Addendum #2 to extend closing date, respond to questions submitted, and provide additional clarification.

# Addendum No. 2

## BND NEW FISHING HARBOR WASTEWATER TREATMENT PLANT

February 28, 2025

SCALE: \_\_\_\_\_  
 SHEET NUMBER: **M2**

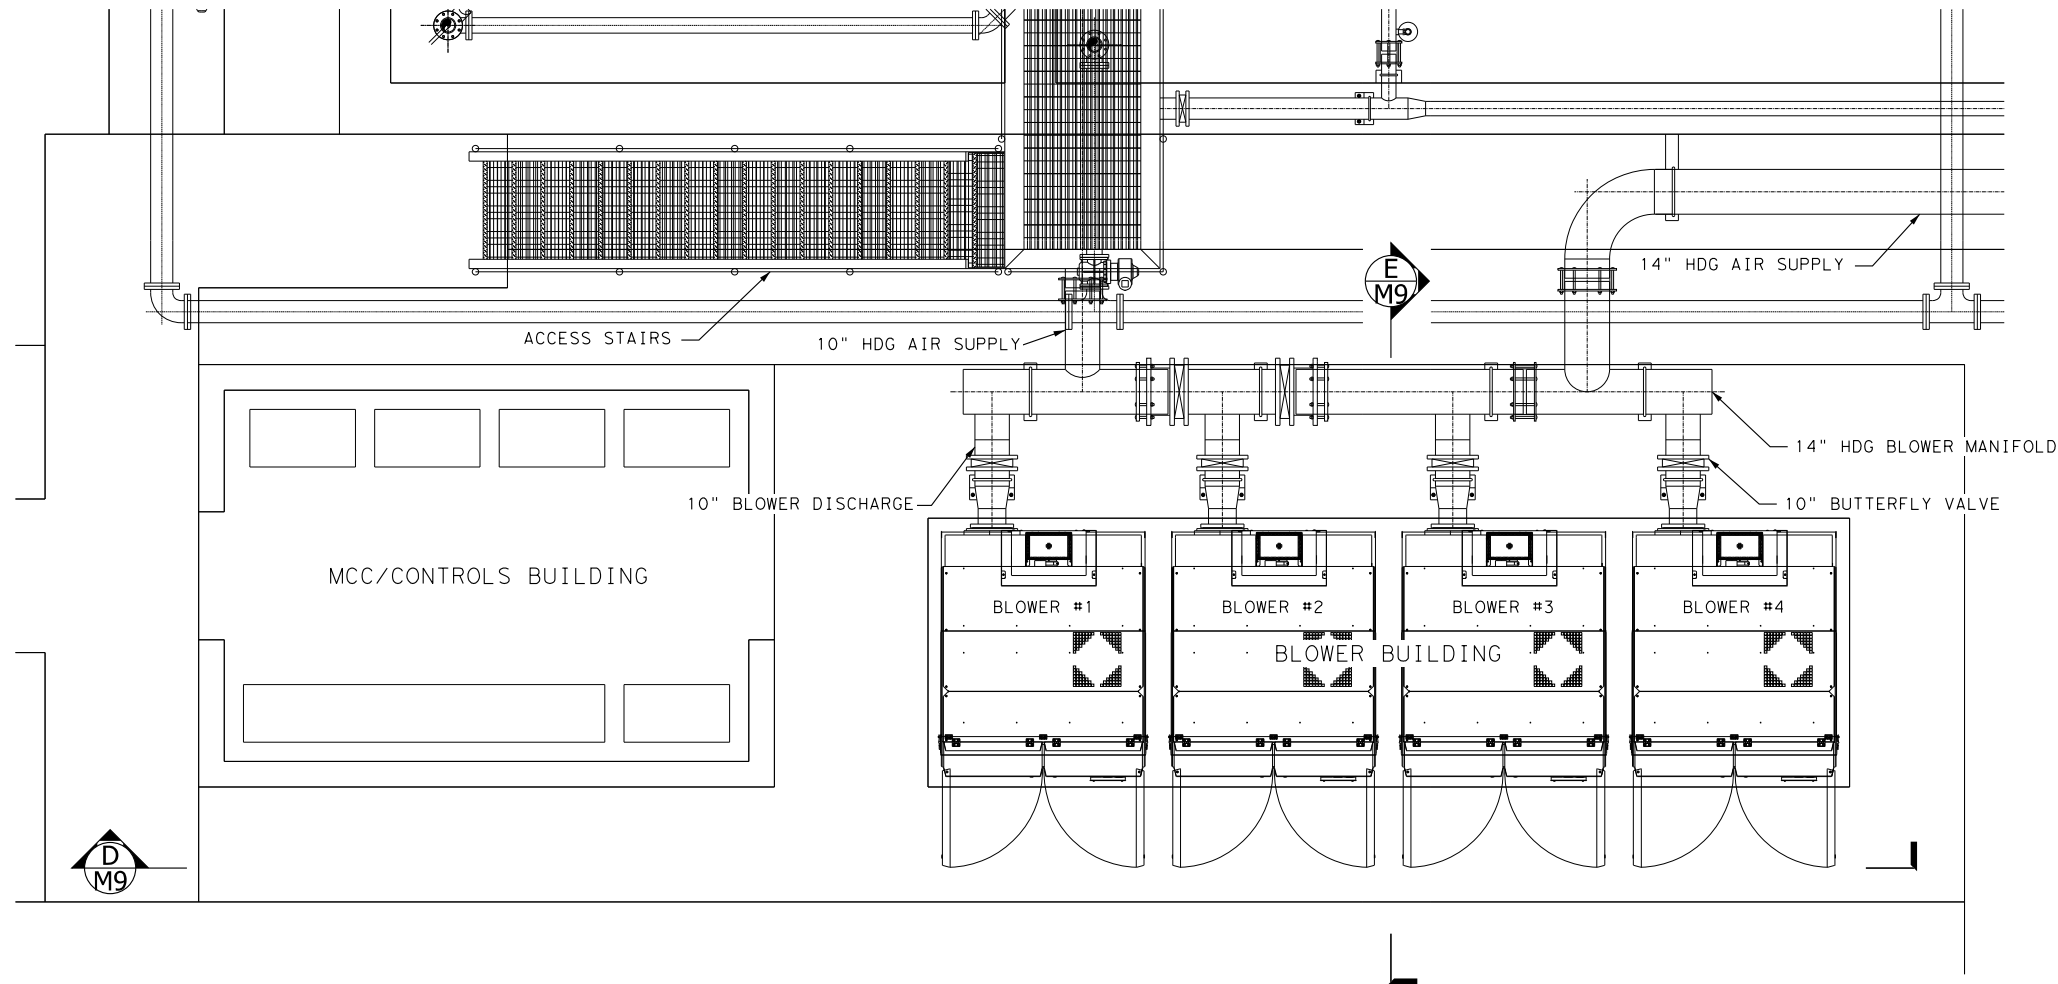
BIDDERS QUESTION	BND RESPONSE
1. There is a spec section for an HTM 15k OWS unit in the drawings. However, there was no detail or schedule for this unit. Is one available or will it be coming out in an addendum?	<i>Details for the OWS unit may be found on sheets M8, M2, 13 and 14 of the construction drawings.</i>
